Subject: RE: Reply: Quick question about Canister downloading simulations at SONGS ISFSI

Subject: [External_Sender] Quick question about Canister downloading simulations at SONGS ISFSI

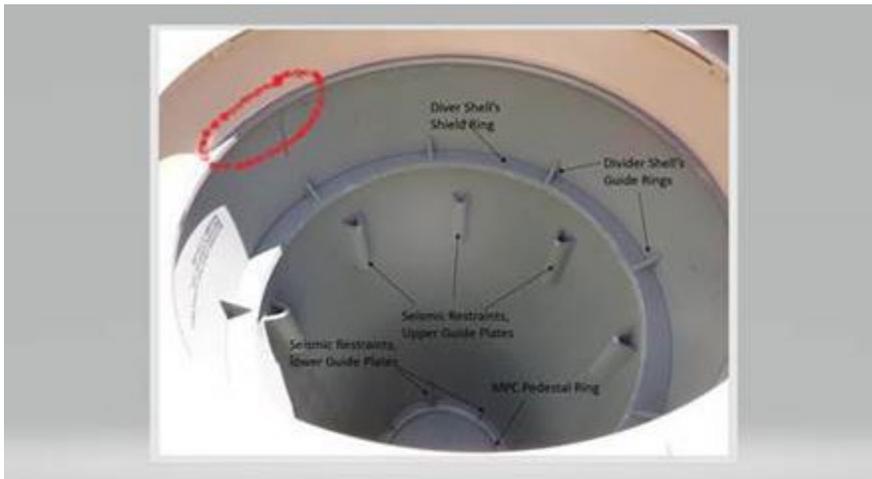
Question #1: I notice that there appears to be no "shield ring" at the top of the silo in the UMAX ISFSI Vault. Is this correct, or am I missing something?

Question #2: When the canister appears to be fully lowered, there is a green ring near what appears to be the bottom of the vault. Is this the shield ring that is responsible for scratches on the canisters?

The following picture shows an inside look at the top of the SONGS UMAX ISFSI vault that was used in the training scenario captured in the video. In the video, when the MPC reached the fully downloaded position, the top of the shield cone can be seen at a location near the top of the storage module (circled area in the picture below). As such, in the [video](#) it is still very difficult (impossible in the snapshot, in my opinion) to see the components below (and inside) the top of the storage module (e.g., shield ring and guide ring) due to the obstructions created by the installed shield cone.

There is a shield ring in the UMAX ISFSI vault as shown in the picture I have provided above. However, the shield ring is difficult to see in the snapshot from YouTube video due to the obstructions created by the geometry of the installed shield cone.

Again, the shield ring cannot be clearly observed in the video as previously explained. The small clearances between the MPC and the interior storage vault components contributed to incidental contact during downloading operations, which resulted in some canister scratching.
